Access Compliance Report

Public Rights-of-Way

(Curb Ramps)

Intersection ID: 14659	Main Street: E_WORTHINGTON_AV	Cross Street: SPRINGDALE_AV	Location: N
ADA ID: 43FA3AF23CFF	Ramp Type: Directional1	Initial Pass/Fail: Fail	Overall Compliance: No
Codes/Mitigation Info/Possible Solution		Field Measurements/Component Compliance

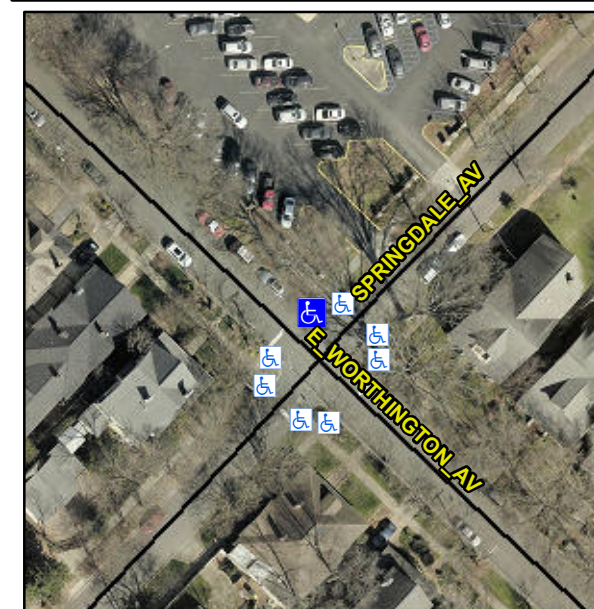
R304.5.1, R304.2.2, R304.5.3

Compliance	Description	Data	Compliance	Description	Data
N/A	Ramp Length (in)	36.0	N/A	Grade Break?	N/A
No	Ramp Width (in)	36.0	N/A	Grade Break Slope (%)	0.0
No	Ramp Slope (%)	12.8	N/A	Grade Break XSlope (%)	0.0
No	Ramp XSlope (%)	5.1			
N/A	Flare Type LT	N/A	N/A	Flare Type RT	N/A
N/A	Flare Slope LT (%)	N/A	N/A	Flare Slope RT (%)	0.0
N/A	Flare Traversable LT?	N/A	N/A	Flare Traversable RT?	N/A
N/A	Landing Length (in)	0.0	N/A	DWS Provided?	N/A
N/A	Landing Width (in)	0.0	N/A	DWS Contrast?	N/A
N/A	Landing Slope (%)	0.0	N/A	DWS Length (in)	N/A
N/A	Landing X Slope (%)	0.0	N/A	DWS Full Width?	N/A
N/A	Landing Curb? (Y/N)	N/A	N/A	DWS Offset LT (in)	N/A
N/A	Shared Landing?	N/A	N/A	DWS Offset RT (in)	N/A
N/A	Gutter Ponding?	0.0	N/A	Gutter Slope (%)	N/A
N/A	Gutter Lip Ht (in)	2.0	N/A	Gutter X Slope (%)	N/A
N/A	Painted X Walk1?	No		Road Slope (%)	6.2
	X Walk 1 Direction	To SW		Road X Slope (%)	0.1
	X Walk 1 Width (in)	N/A		Clear Space?	N/A

Remove & Replace Entire Ramp.
